UNITED STATES PATENT AND TRADEMARK OFFICE

| APPLICATION NO. | FILING DATE | FIRST NAMED INVENTOR | ATTORNEY DOCKET NO. | CONFIRMATION NO. |
|---|-------------|----------------------|---------------------|------------------|
| 10/711,193 | 08/31/2004 | James A. Cooke | IP 116.1 | 5192 |
| SRAM CORPORATION 1333 N. KINGSBURY, 4TH FLOOR CHICAGO, IL 60622 | | | | RASHID, MAHBUBUR |

DETAILED ACTION

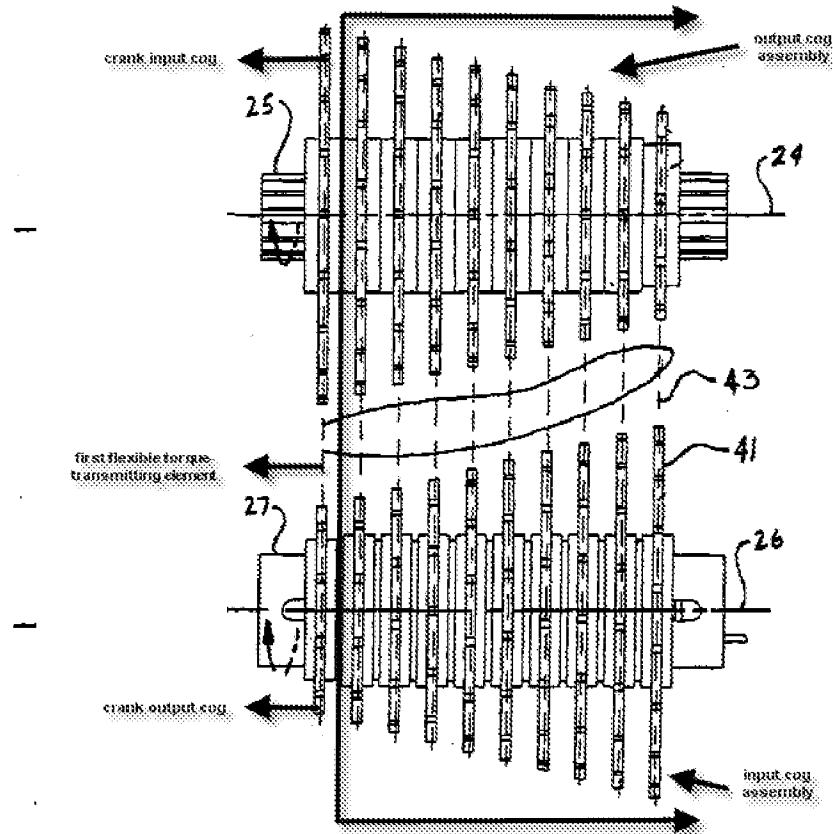
an input device (fig. 13, (76)), the output shaft (fig. 2, (25); see also [0085]) is connected to the input shaft (fig. 2, (27); see also [0085]) by a first flexible torque-transmitting element (chain) (see fig. above) and a second flexible torque-transmitting element (drive chain) (fig. 13, (80));

Re-claim 4, see a crank input cog and a crank output cog (see fig. above).

transmitting element (chain) (see fig. above) and a second flexible torque-transmitting element (drive chain) (fig. 13, (80));

Re-claim 13, see a crank input cog and a crank output cog (see fig. above).
